Section 75W Modification Application Environmental Assessment Report

Central Park, Broadway

Modification to Approved Concept Plan MP06_0171 (Mod 9)

January 2014 ■ 13600

Figure 1 – Existing and proposed Block 4S building envelope

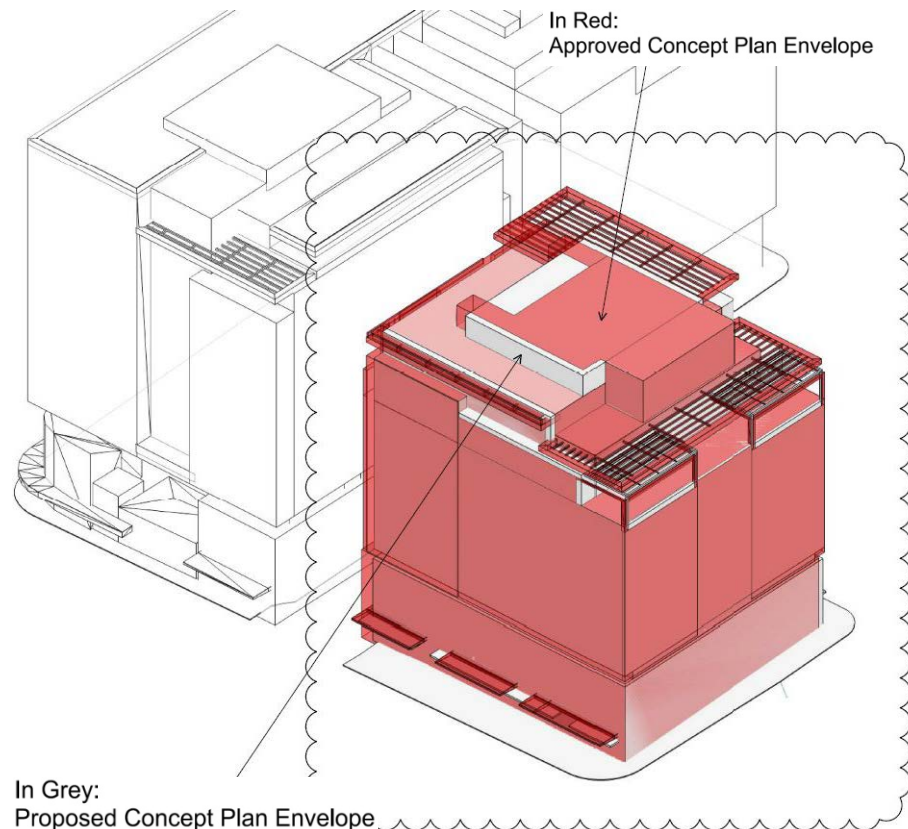
The modifications proposed to the Block 4S envelope (from the approved Mod 8 envelope) relate only to the following elements. The remainder of the building envelope remains as approved.

- Separation of Block 4S and 4N in accordance with the determination of SSD 5700-2012, resulting in a reduction of building mass to the north of Block 4S
- Minor alterations to the upper levels, and setbacks in accordance with the approved Block 4S SSD application
- Simplification of the facade and envelope, removing unnecessary facade articulation

Figure 2 – Proposed orientation of Block 8 (Mod 8 shown in heavy red dotted line)

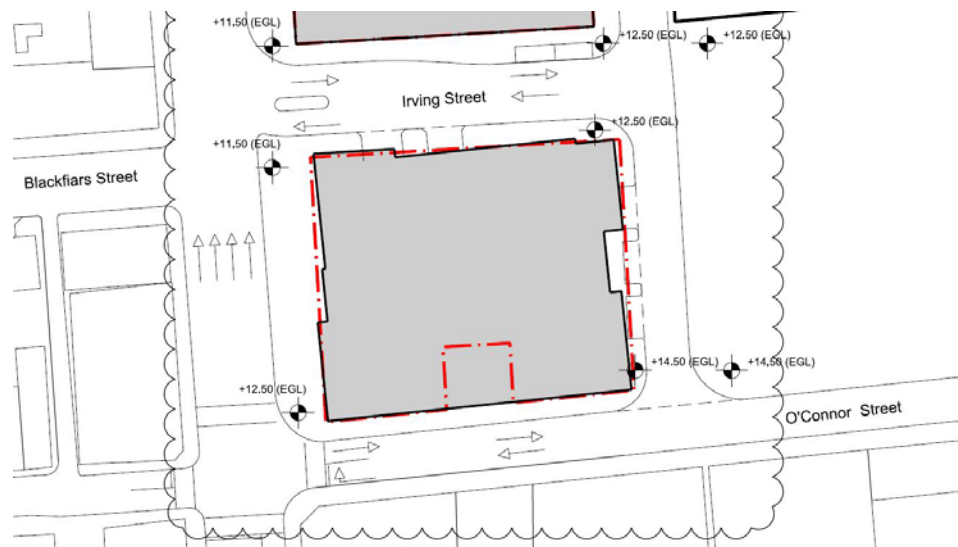
As illustrated on the Concept Plan Comparison Plan (**Appendix C**), the proposed modification to the Block 8 building envelope, primarily relate to changes of the 'stepped' form and building articulation. Minor variations are proposed to the setback as well as a minor amendment in the orientation of this building, as shown in **Figure 2** below. The proposed amendments to the concept plan are proposed to ensure consistency with the concurrent Block 8 SSD design submitted to the DPI.

Figure 3 – Existing and Proposed Public Domain – Block 1

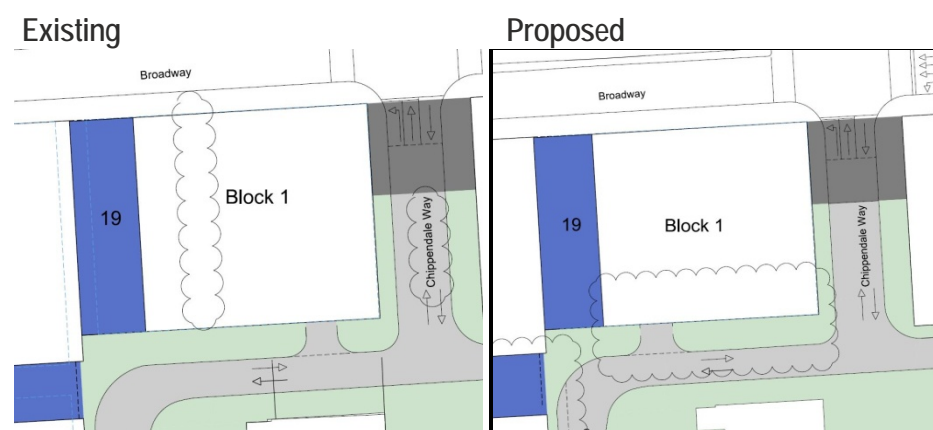
The proposed modification seeks to relocate the main pedestrian entry to the building from the southern facade, fronting Central Park Avenue to the eastern facade, fronting Chippendale Way. **Figure 3** below identified the existing and proposed location of the entry which has been considered by the project architects Foster + Partners as part of design exploration of future developments on Block 1.

Figure 4 – Existing and Proposed Public Domain – Block 4S

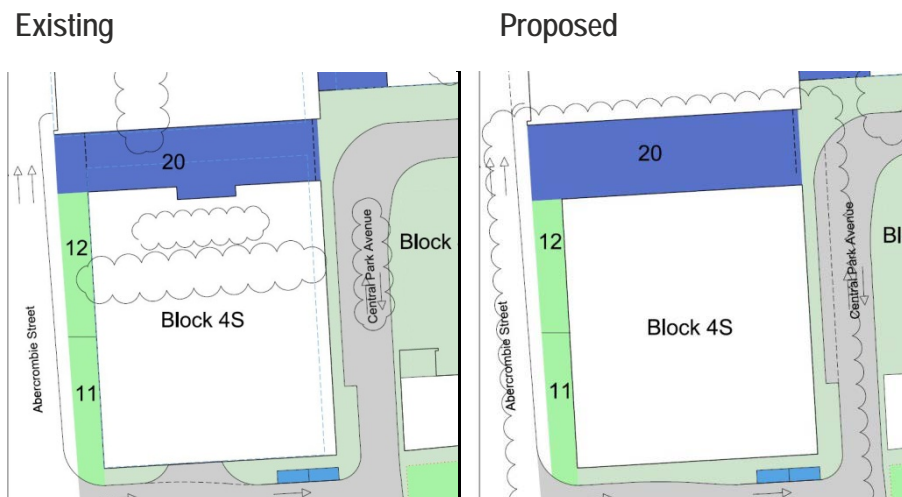
In response to recent determination by the PAC (December 2013), in particular a condition of consent (Condition B2(a)) of SSD 5700-2012 required a greater separation between Blocks 4N and 4S than was proposed within the SSD. In response to this condition the proponent has sought to revise the design of Block 4S, increasing the separation distance to beyond 14.5m as shown on the Concept Plan drawings (**Appendix A**).

As a result of the increased separation, the size (width) of the 'Publicly Accessible Throughway' between Block 4N and 4S increases. The Concept Plan drawings (**Appendix A**) reflect this amendment. The existing and proposed arrangement is shown below in **Figure 4**.

Figure 7 – Existing and proposed vehicle access – Block 4S

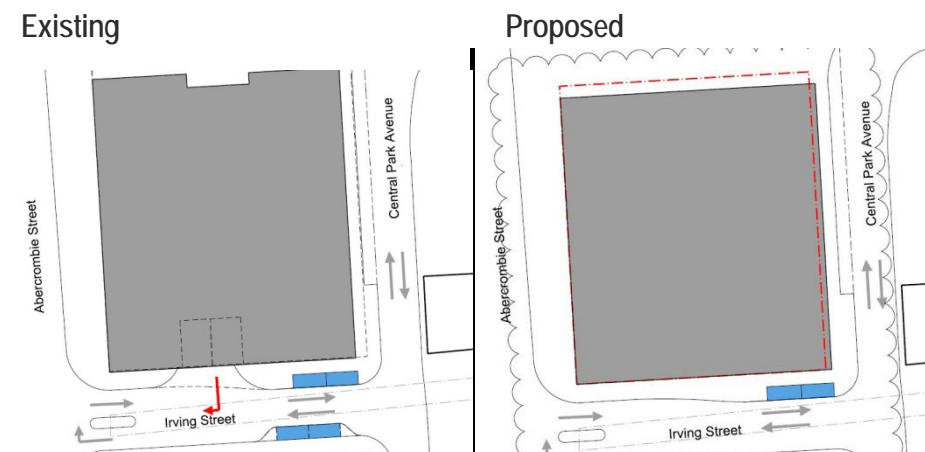
This modification seeks removal of the vehicle entry to the southern elevation of Block 4S. As part of the design development and subsequent final design of the Block 4S SSD scheme, access from the southern elevation was moved, given the consideration of future access to be provided from the Block 1 + 4N basement.

The amendment to the concept plan therefore reflects the approved design to Block 4S in accordance with the SSD application. The existing and proposed arrangements for this block are shown below in **Figure 7**.

Figure 8 – Existing and proposed vehicle access – Block 8

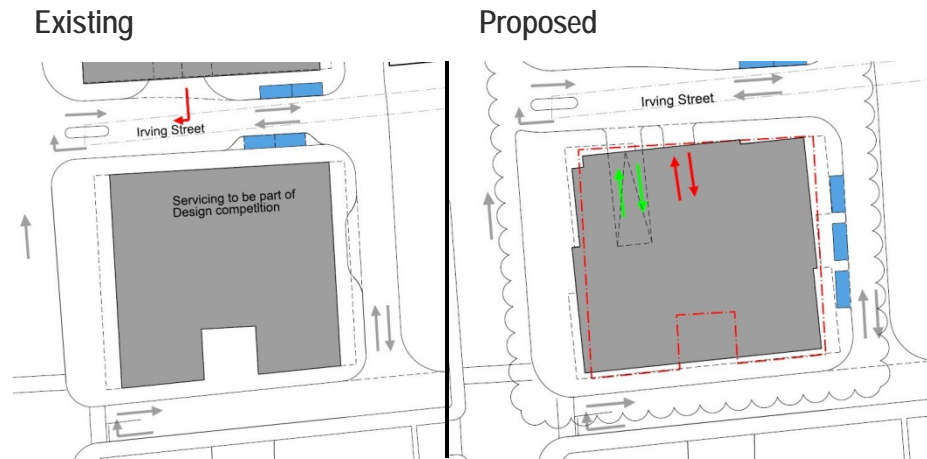
The proposal involves the provisions of a new vehicle access to the northern elevation of Block 8 following the excise of the Block 8 basement car park from the combined Block 1 +4 basement car park to the north. The location of the vehicles access and subsequent amendments to the pedestrian footpath, have been determined in consultation with City of Sydney in preparation of the SSD for Block 8. The proposal seeks to amend the concept plan to be consistent with this proposal. The existing and proposed arrangements for this block are shown below in **Figure 8**.
